# UNITED STATES PATENT AND TRADEMARK OFFICE

APPLICATION NO.	FILING DATE	FIRST NAMED INVENTOR	ATTORNEY DOCKET NO.	CONFIRMATION NO.
10/656,915	09/08/2003	Daniel H. Hazelton		8642
7590 11/16/2004				
Daniel H. Hazelton 55 Nunan Street Charleston, SC 29403		EXAMINER CHAMBERS, MICHAEL S		
		ART UNIT 3711 PAPER NUMBER

<b>Office Action Summary</b>	<b>Application No.</b> 10/656,915	<b>Applicant(s)</b> HAZELTON, DANIEL H.	
	<b>Examiner</b> Mike Chambers	<b>Art Unit</b> 3711

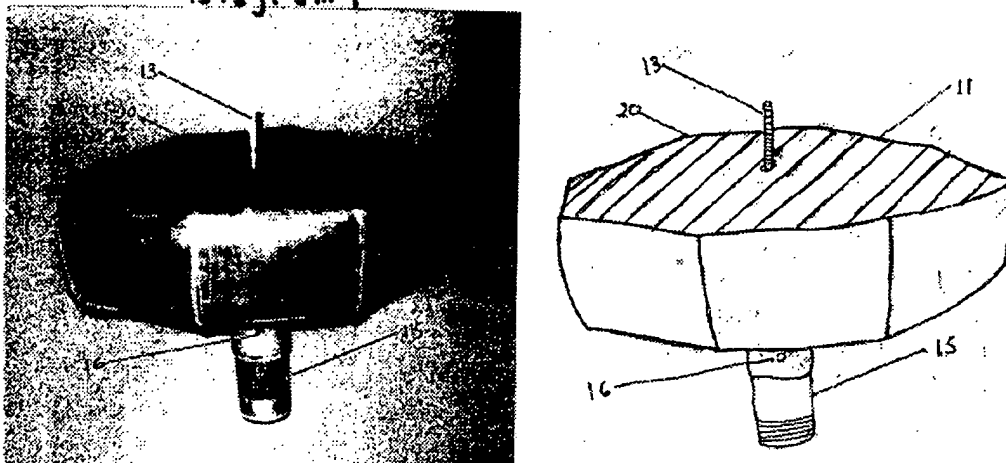
The added material which is not supported by the original disclosure is as follows:

Fig 7 item 11 is disclosed as a planar surface.

Fig 7 item 13 is disclosed as a threaded rod.

Fig 7 item 15 is disclosed as a threaded pipe.

Applicant is required to cancel the new matter in the reply to this Office Action.

Figure 10

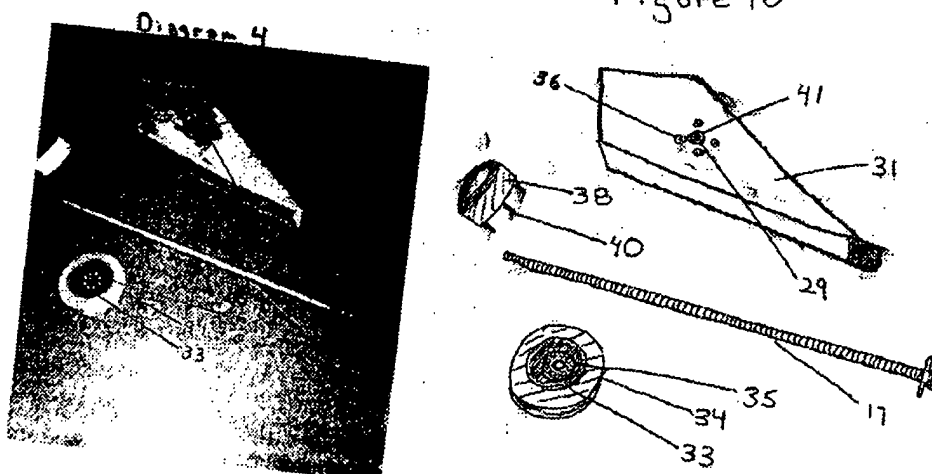
Fig 10 items 36,41,29,31,38,40,17 are disclosed.

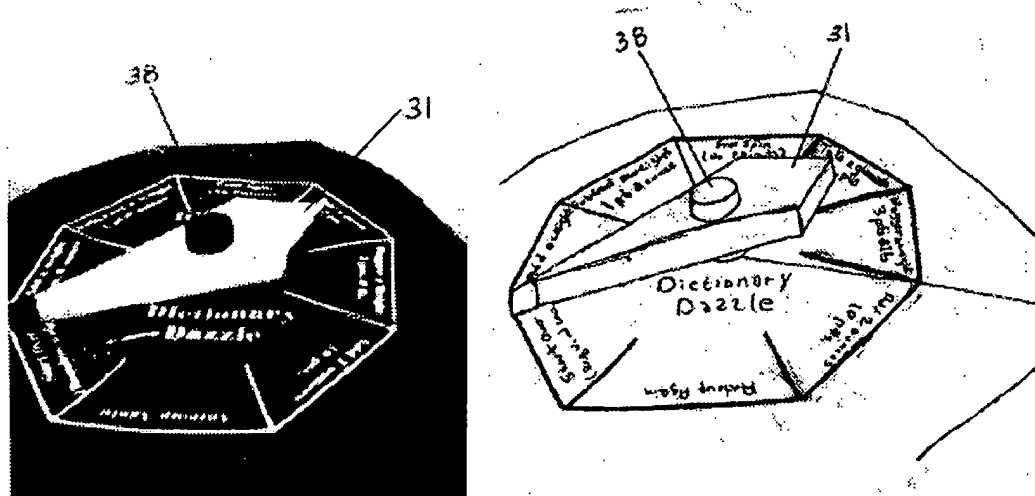
Fig 11 indicia is considered new matter
